## IEEE P802.15 Wireless Personal Area Networks

Project	IEEE P802.15 Working Group for Wireless Personal Area Networks (WPANs)	
Title	<b>TG3 SB1 comment resolution</b>	
Date Submitted	[21 February, 2003]	
Source	[James P. K. Gilb] [Apparent Technologies] [15373 Innovation Drive, #210, San Diego, CA 92129]	Voice: [858-485-6401] Fax: [858-485-6406] E-mail: [gilb@ieee.org]
Re:	[]	
Abstract	[This document is a record of comment resolutions for SB1.]	
Purpose	[To provide a record of the comment resolution for SB1.]	
Notice	This document has been prepared to assist the IEEE P802.15. It is offered as a basis for discussion and is not binding on the contributing individual(s) or organization(s). The material in this document is subject to change in form and content after further study. The contributor(s) reserve(s) the right to add, amend or withdraw material contained herein.	
Release	The contributor acknowledges and accepts that this contribution becomes the property of IEEE and may be made publicly available by P802.15.

**Figure 6—MSC for acquiring DEV IEs using the Probe Request command.**

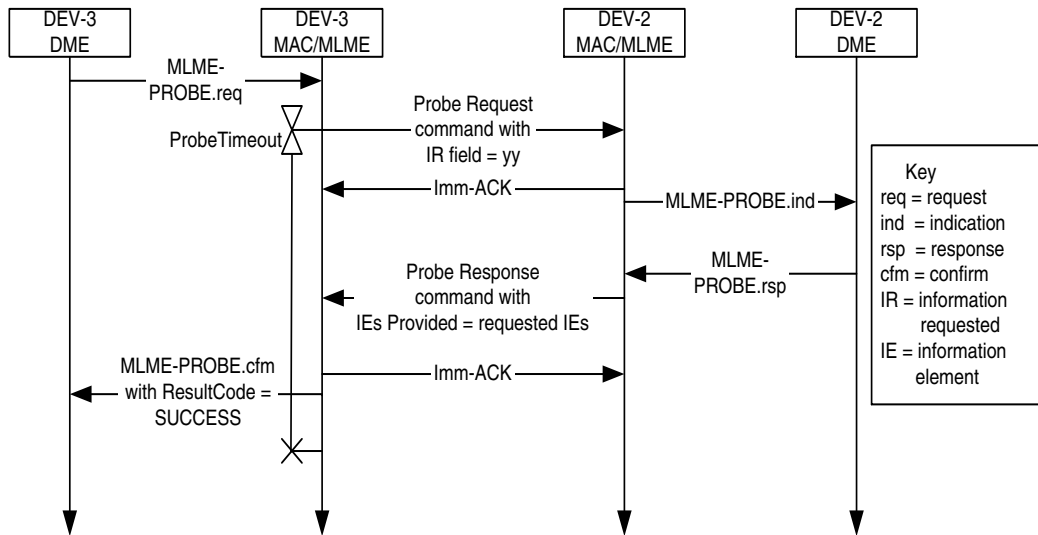
Replace Clause 8.9.2 with the following text:

Figure 6 illustrates the sequence of messages involved in acquiring DEV IEs from a target DEV using the Probe Request command.

**Figure 8—CTRq time unit covering multiple frames with CTRq TU MIFS = 1**

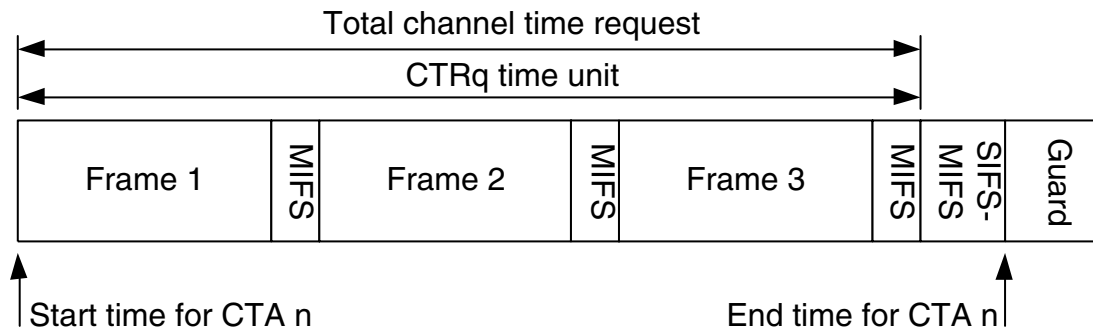
CID 682 - Needed to add one more figure, see also 03/059r0 for complete section. The new figure and text are:

Figure 8 shows a multi-frame CTRq with the CTRq TU MIFS field set to 1.

**Figure 15—Channel time request for frames with immediate ACKs**

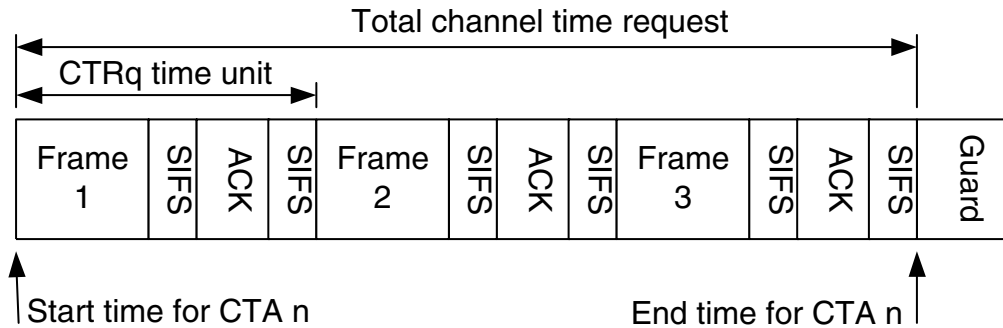
CID 682: - **Suggest accept in principle:** The inclusion of MIFS changed the CTR calculations, but the changes were not reflected in 8.4.4.6. '1)Change b3 in Figure 79 from "stream termination" to "MIFS CTRq TU". 2)Replace page 152, line 12 with:

requests. Figure 15 (was #108) shows an example of channel time being requested for a CTA where Imm-ACKs are used.
